Re: Written Argument of Joe Bundrant in Support of Hearing Examiner's Amended Decision
Reference: File No's. 11-101457 LU/VAR, 11-101461 SM, 11-101464 RC, 11-101008
LDA, & 11-101007 SP

**Exhibit S-2 Written Argument from Clayton Graham by email
Sep 7 2018
PFN: 11-101457 LU**

Re: Point Wells Development Public Comments
Reference: File No: 11 101457 LU, et. al.

Re: Comments on the Scope of the Environmental Impact Statement for the Point Wells Development, File Nos. 11-101457; 11-101461 SM; 11-101007 SP; 11-101008 LDA; and 11-101464 RC

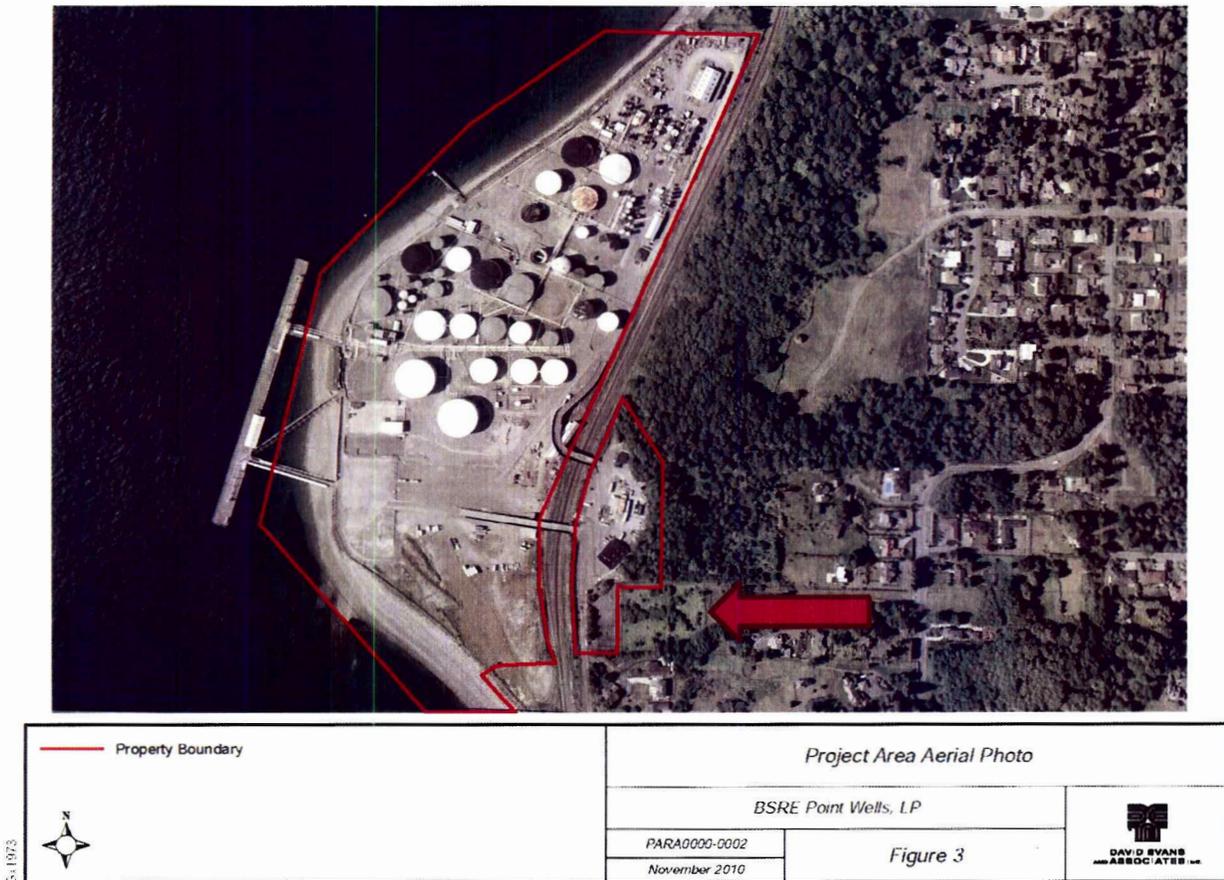
The “No Action” Alternative is not truly “no action” because it contemplates expansion of “underutilized existing facilities,” without sufficient evidence of any demand for such increased utilization. In other words, the “alternatives” presented are large-scale industrial development, large-scale residential/commercial development, and larger-scale residential/commercial development. In order for the EIS to provide a useful benchmark by which to analyze such a massive increase in intensity of development, PDS should consider lower impact alternatives as suggested by Save Richmond Beach and Richmond Beach Advocates in their SEPA scoping comments.⁴ The County must also consider the true “no action” alternative of continuing use of the site as an industrial facility *as currently utilized*.

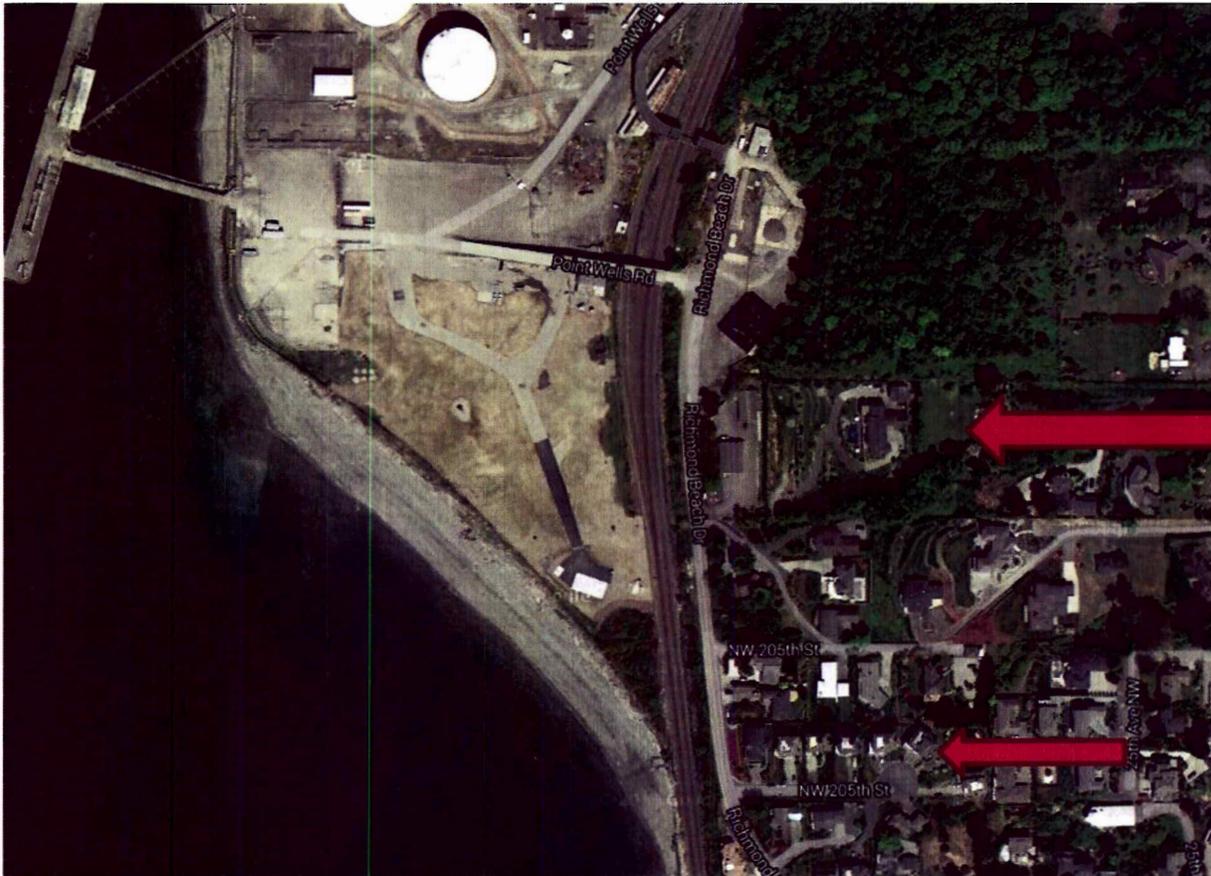
The area surrounding the Project site has changed since 2011 and the SEPA checklist does not take these changes into account. Notably, the Bundrants' home is located in the area indicated by the red arrow in the graphic above, but does not appear in the above map. Nor does it show the numerous houses that are located to the southeast of the Project site—all of which can be seen in the following aerial photo, which we accessed through Google Maps several days ago. In the following graphic, the location of these residences is indicated with red arrows.

The Project will have significant adverse impacts on all of these properties, and these impacts must be taken into account in the DEIS for the Project. The view impacts alone deserve particular attention, as the Project could nearly eliminate the view of the Sound and the Olympics for many of these owners. These impacts are not acknowledged or discussed in the SEPA documents provided for the Project. Notably, some of the buildings in the Project (specifically, those identified as SV-T 3 through 5 in the Project documents) are slated to be eight to twelve stories tall, and will tower over nearby homes—possibly as much as 120 feet. Yet, the applicant’s View Impact analysis does not acknowledge this impact, or present a cross-section showing the relative heights of development for this location.⁵ PDS must conduct a thorough view impact analysis as part of the DEIS, and should not rely on the limited information provided in the SEPA Checklist for the Project.
